ANSTY GARDEN COMMUNITY,

DESIGNERS RESPONSE

REPORT REF NO. 2207280-R15

Road Safety Audit Stage 1

Drawing Title:
PROPOSED ROUNDABOUT SOUTHERN ACCESS (B2036)

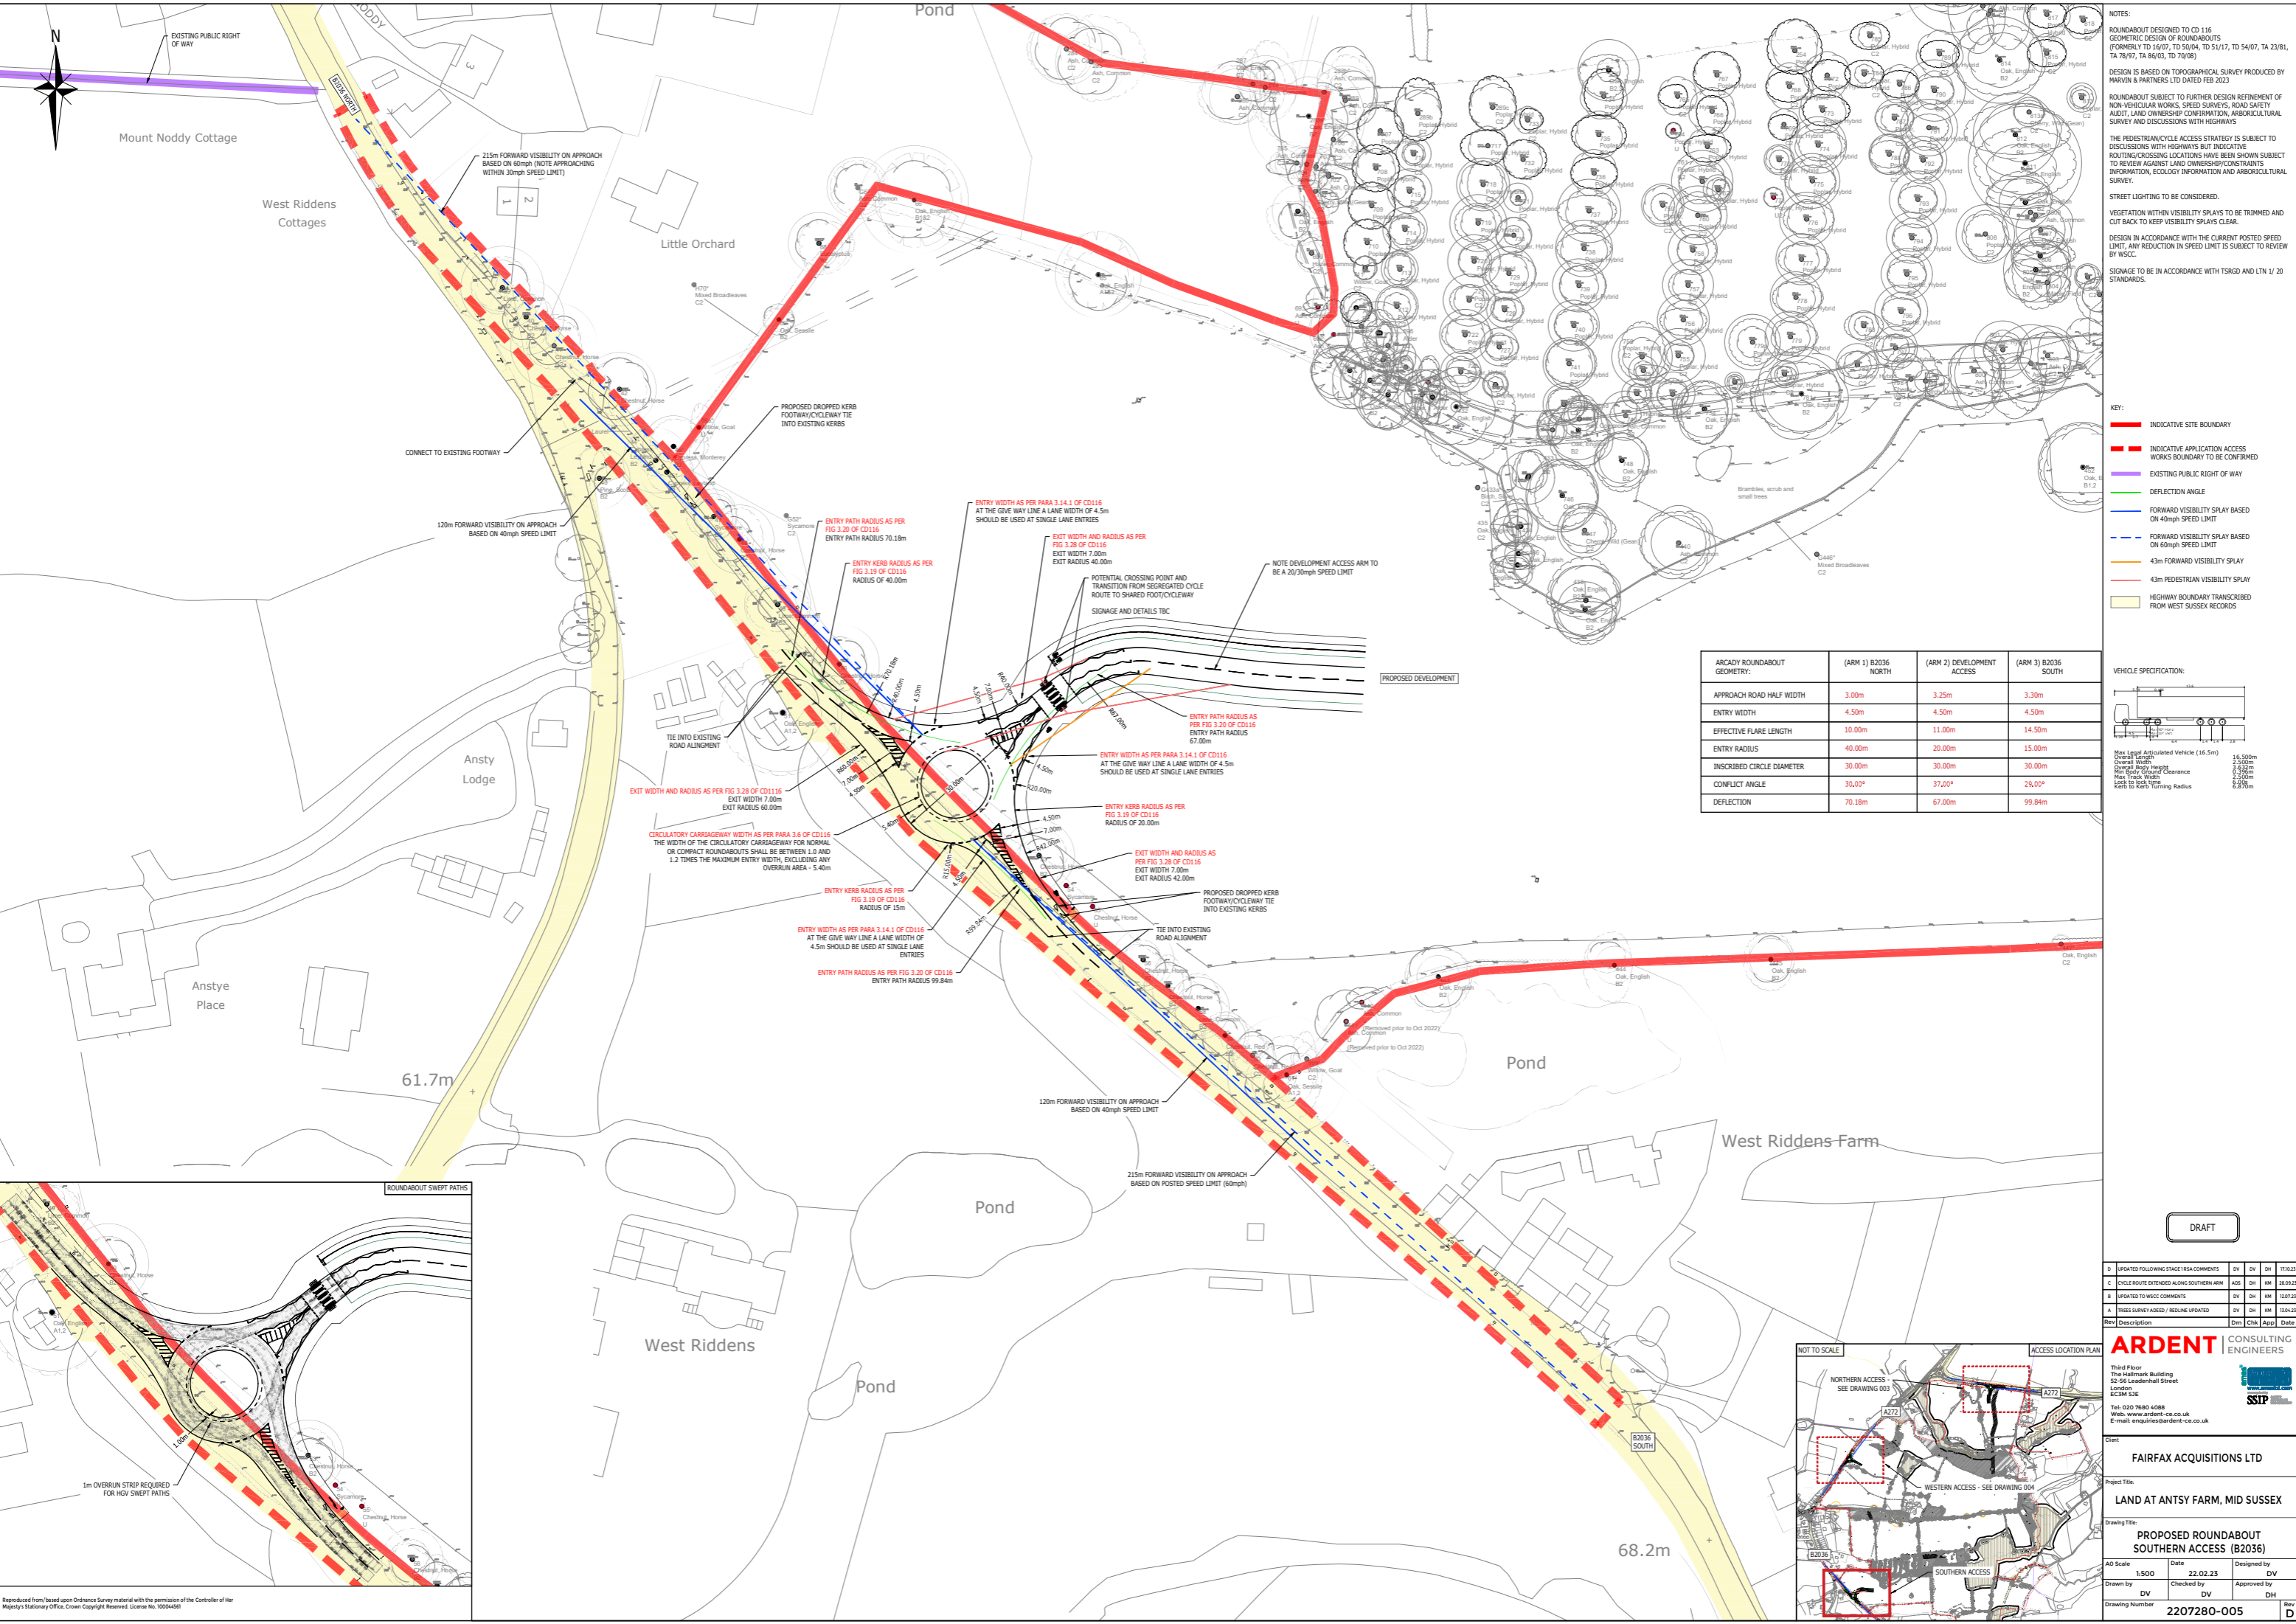
<p>3.1.4 Inappropriate surfacing could lead to vehicle to pedestrian / cyclist collisions or rear end shunts.</p> <p>The proposals do not include the introduction of anti-skid surfacing or a surface with a high polished stone value on the approaches to the Parallel crossing. Surfacing with an inadequate PSV could lead to vehicles not being able to stop, leading to possible rear end shunt or vehicle to pedestrian / cyclist collisions.</p>	<p>It is recommended that antiskid surfacing or surfacing with a high PSV should be used on the approaches to the crossing.</p>	<p>Details of PSV values and surfacing materials will be provided for Stage 2 Audit</p>		
<p>3.2.1 Approaches to the proposed roundabout.</p> <p>Stopping Sight Distances (SSD) have been provided for assessment and at 215m are acceptable for the current national speed limit. An insufficient SSD may increase the risk of junction related or shunt type collisions at the roundabout and so the 120m SSD, which is commensurate with a 40mph design speed, should only be incorporated if a reduced speed limit of 40mph is introduced.</p>	<p>It is recommended that the SSD should be commensurate with the design speeds.</p>	<p>The proposed roundabout will significantly change the nature of speeds approaching the proposed crossing location, resulting in lower than compared to the current speeds</p> <p>Visibility splays for the current posted speed has been shown and noted to be kept clear to be robust at this stage.</p> <p>A change in speed limit is at the discretion of WSCC but agreed, if there is a change, the splays provided will be in accordance with speed limit.</p>

As presented on ACE Drawing 2207280-005D , the design incorporates suitable visibility splays based on the current posted speed limit.		
<p>3.2.2 Insufficient Stopping Sight Distance may increase the risk of junction related or shunt type collisions at the roundabout.</p> <p>On the westbound approach to the roundabout no SSD has been provided for assessment. There is concern that the SSD could pass over non-highway land. Vegetation or landscaping features in this splay could restrict visibility, where insufficient visibility may increase the risk of junction related or shunt type collisions at the roundabout.</p>	<p>It is recommended that the SSD should be supplied for assessment and that they should be within the adoptable highway, or that a suitable covenant should be arranged to ensure that the splay is not affected by planting or landscaping features.</p>	<p>All visibility splays are within highway land or land within the development site and therefore can be kept clear as shown and noted on ACE Drawing 2207280-005D.</p>

<p>provided for assessment. There is concern that inappropriate vertical profiles could restrict visibility at the junction, which may lead to side impact collisions and loss of control collisions.</p>				
<p>3.2.4 Restricted Stopping Sight Distance may increase the risk of vehicle to pedestrian / cyclist collisions or rear end shunts.</p> <p>On the westbound approach to the Parallel crossing no SSD has been provided for assessment. There is concern that the SSD could pass over non-highway land. Vegetation or landscaping features in this splay could restrict visibility, where restricted SSD may increase the risk of vehicle to pedestrian / cyclist collisions or rear end shunts.</p>	<p>It is recommended that the SSD should be supplied for assessment and that they should be within the adoptable highway, or that a suitable covenant should be arranged to ensure that the splay is not affected by planting or landscaping features.</p>	<p>The proposed parallel crossing is located on the development access arm and will be subject to a 20/30mph speed limit subject to public transport requirements.</p> <p>Suitable visibility splays are proposed of 43m with visibility splays shown on ACE Drawing 2207280-005D.</p>

VEGETATION WITHIN VISIBILITY SPLAYS TO BE TRIMMED AND CUT BACK TO KEEP VISIBILITY SPLAYS CLEAR.

DESIGN IN ACCORDANCE WITH THE CURRENT POSTED SPEED LIMIT. ANY REDUCTION IN SPEED LIMIT IS SUBJECT TO REVIEW BY WSCC.
